Administrative Approval Action

Case File / Name: ASR-SR-90-2018
Brier Creek Town Center Westin

- REQUEST:** This is a revision to a site plan previously approved on January 30, 2019 (SR-90-2018) involving the development of a hotel on a 4.78 acre site within a 37.89 acre Planned Development. The original approval (AA# 3923, #569715) allowed for a 228 unit, 190,668 square foot hotel including retail and restaurants. This revised plan (AA# 4027) allows for a 236 room, 200,228 square foot hotel including retail and restaurants. The sunset date for this plan is unchanged.

BRIER CREEK TOWN CENTER WESTIN HOTEL

BRIER CREEK TOWN CENTER WESTIN HOTEL ADMINISTRATIVE SITE REVIEW RALEIGH, NORTH CAROLINA UTILITY PLAN - AREA "B"

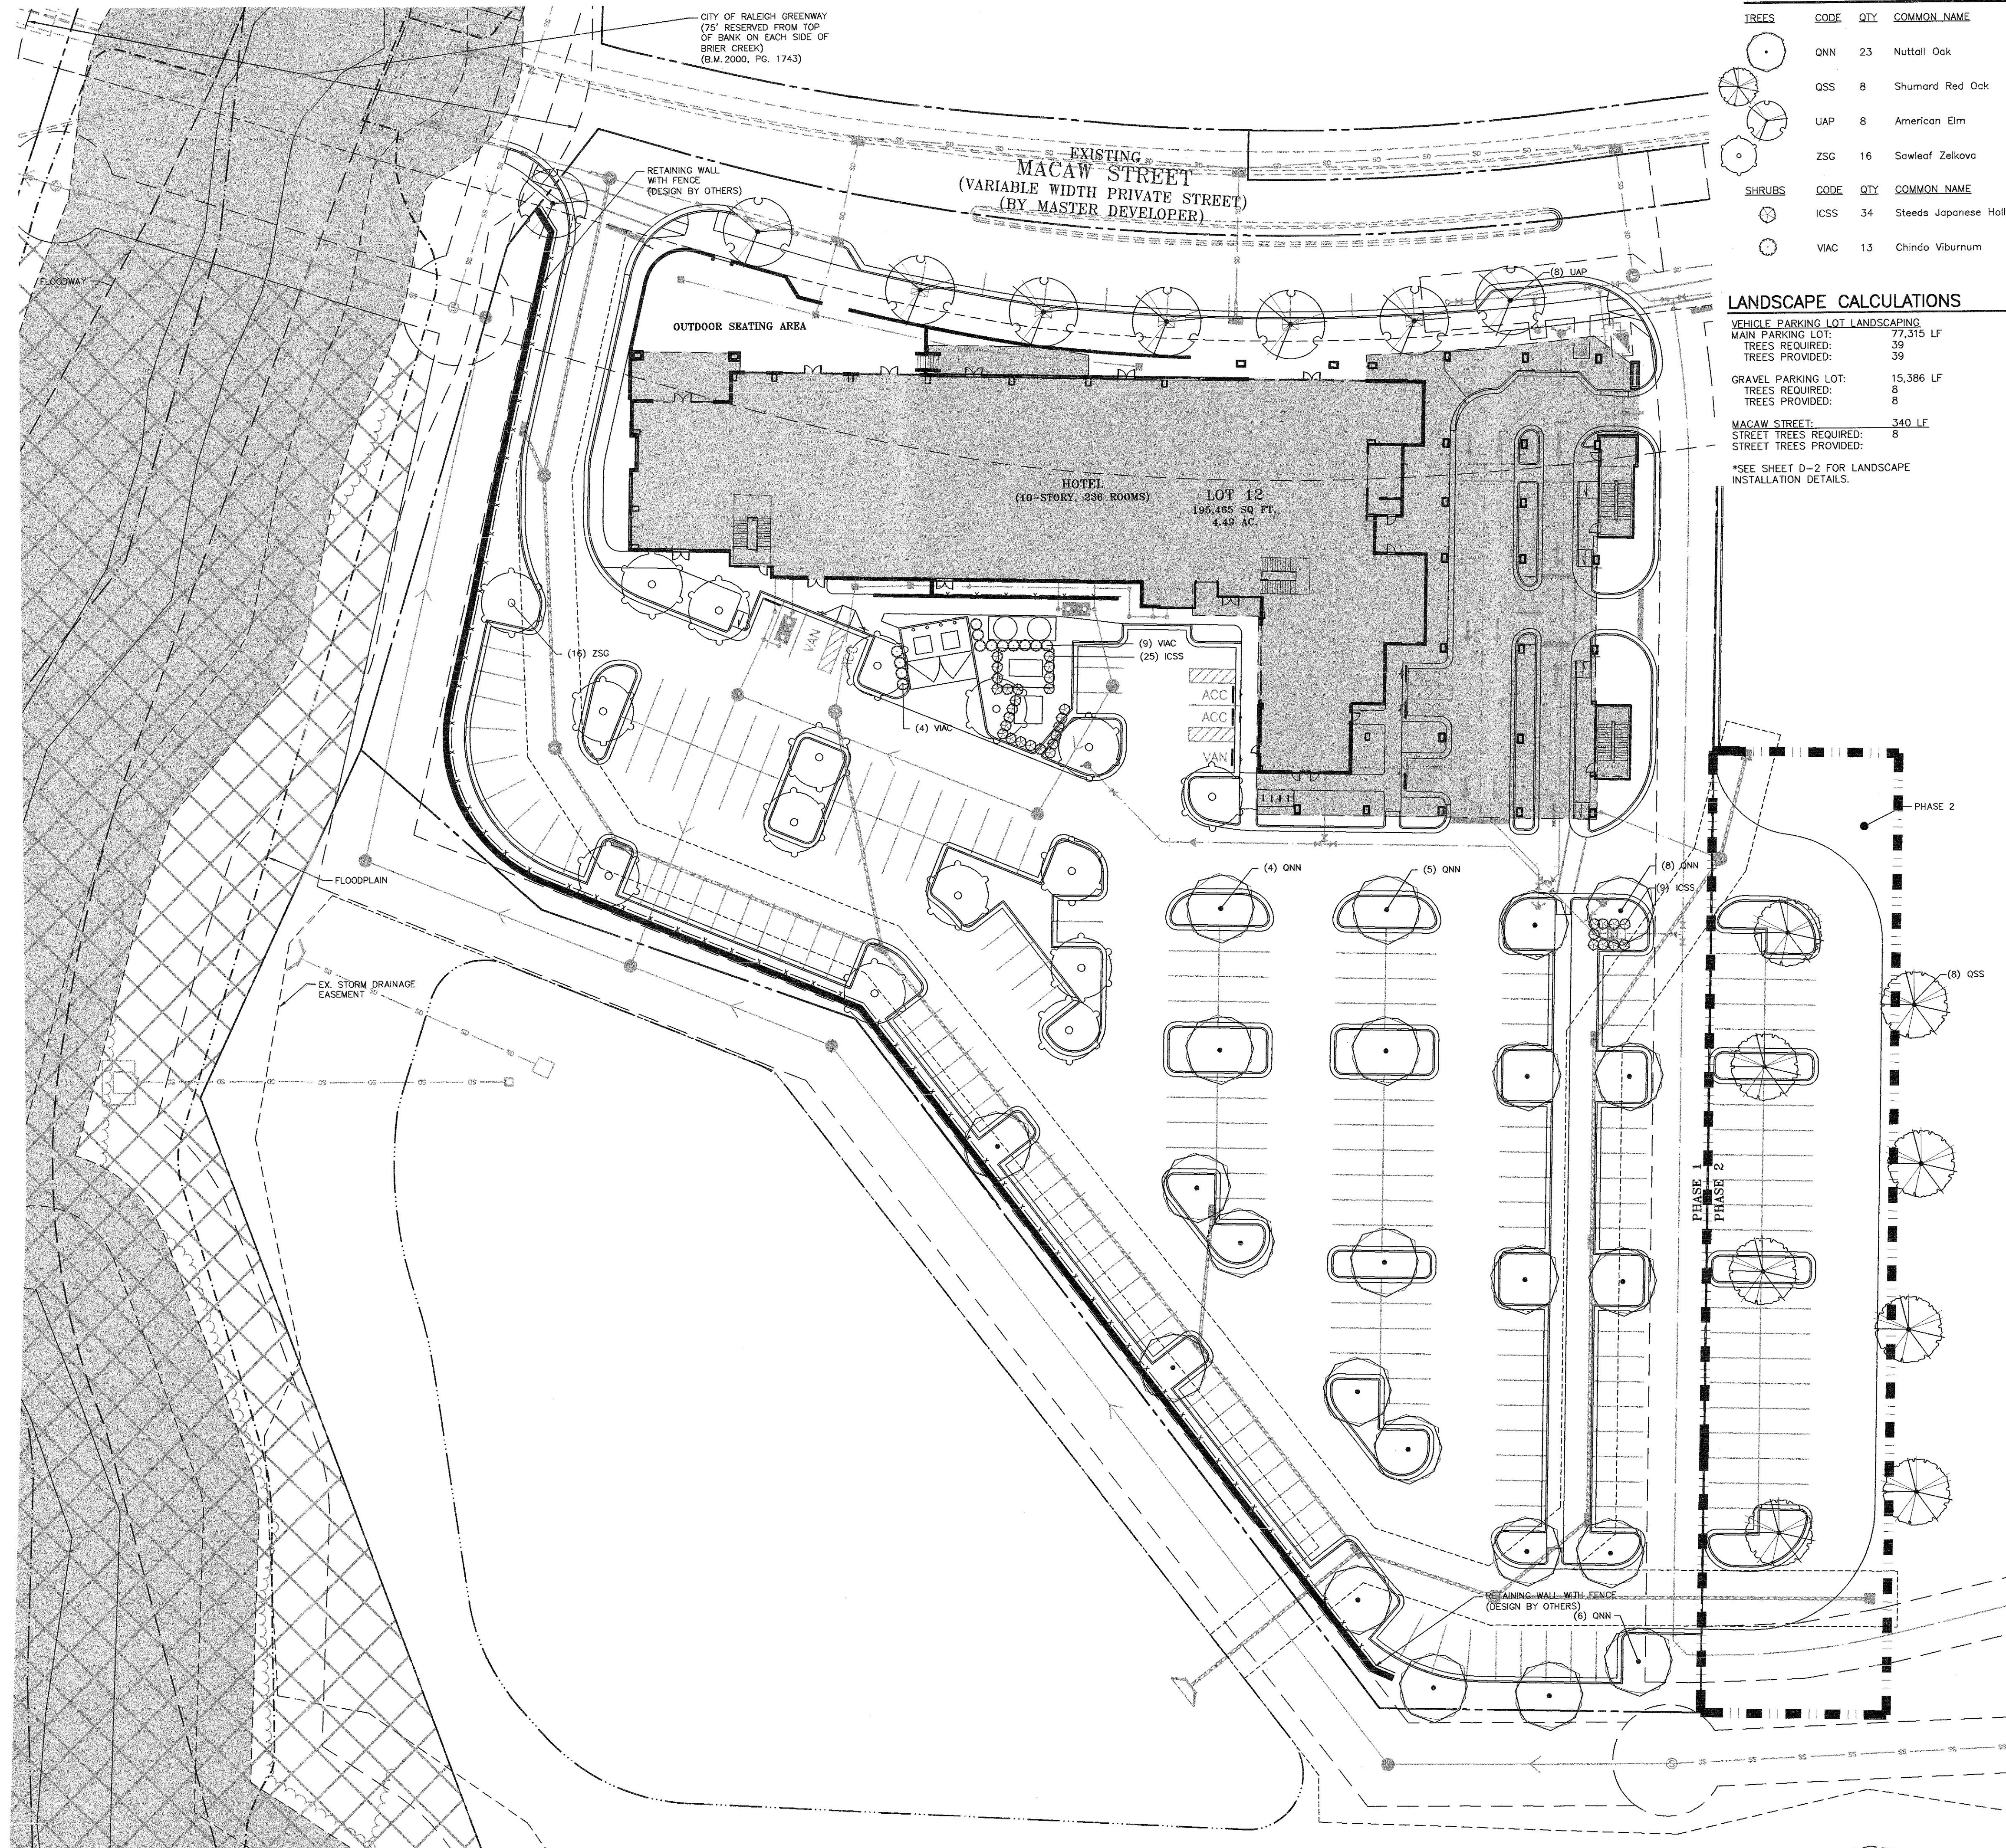
1. The area shown as "NEW VARIABLE WIDTH PUBLIC ACCESS EASEMENT" will need to be recorded to match what is shown on the site plan of SR-90-2018.
